Access Compliance Report Public Rights-of-Way (Curb Ramps)

Main Street: ABYSSINIAN_WAY		Cross Street: CLYDESDALE_DR		Location:	S
ADA ID: RPRK211110132335	Ramp Type: Type 4 - Parallel	Initial Pass/Fail: Fail	Overall Compliance: No	Severity Score:	30

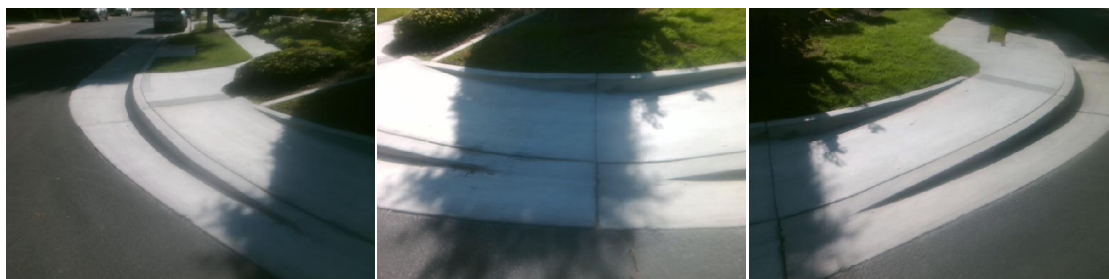
Compliance	Description	Data	Compliance	Description	Data
N/A	Ramp Length LT (in)	133	N/A	Ramp Length RT (in)	142
Yes	Ramp Width LT (in)	52	Yes	Ramp Width RT (in)	52
Yes	Ramp Run Slope LT (%)	2.8	No	Ramp Run Slope RT (%)	12.7
Yes	Ramp Cross Slope LT (%)	0.6	Yes	Ramp Cross Slope RT (%)	0.1
N/A	Landing Present	N/A	N/A	DWS Provided	N/A
N/A	Landing Length (in)	N/A	N/A	DWS Contrast	N/A
N/A	Landing Width (in)	N/A	N/A	DWS Length (in)	N/A
N/A	Landing Run Slope (%)	N/A	N/A	DWS Full Width	N/A
N/A	Landing Cross Slope (%)	N/A		DWS Offset Type	N/A
N/A	Landing Movement Obstructed?	N/A	N/A	DWS Offset Left (in)	N/A
	Landing Movement Type	N/A	N/A	DWS Offset Right (in)	N/A
N/A	Landing Shared	N/A			
N/A	Clear Space	Yes			
N/A	Clear Space To Crosswalk (in)	N/A			
N/A	Marked Crosswalk 1	No	N/A	Marked Crosswalk 2	No
	Crossing 1 Direction	NE		Crossing 2 Direction	NW
	Marked Crosswalk 1 Width (in)	N/A		Marked Crosswalk 2 Width (in)	N/A

N/A	Ramp Inside Crosswalk 1	N/A	N/A	Ramp Inside Crosswalk 2	N/A
	Crossing 1 Slope (%)	1.8		Crossing 2 Slope (%)	0.5
	Crossing 1 Cross Slope (%)	0.7		Crossing 2 Cross Slope (%)	7.3
N/A	Gutter Ponding	N/A	N/A	Curb Slope	8.7
Yes	Gutter Lip Height (in)	0		Road Run Slope (%)	3.3
N/A	Gutter Run Slope (%)	N/A		Road Cross Slope (%)	6.5
N/A	Gutter Cross Slope (%)	N/A	No	Perpendicular Joint Present	No
Yes	Overall Surface Condition	Acceptable			
	Cross Gutter Present?	No		Spandrel Present?	No
	Replace Cross Gutter?	N/A		Replace Spandrel?	N/A

Remove & Replace Curb Ramp With Two New Directional Ramps or Equivalent.
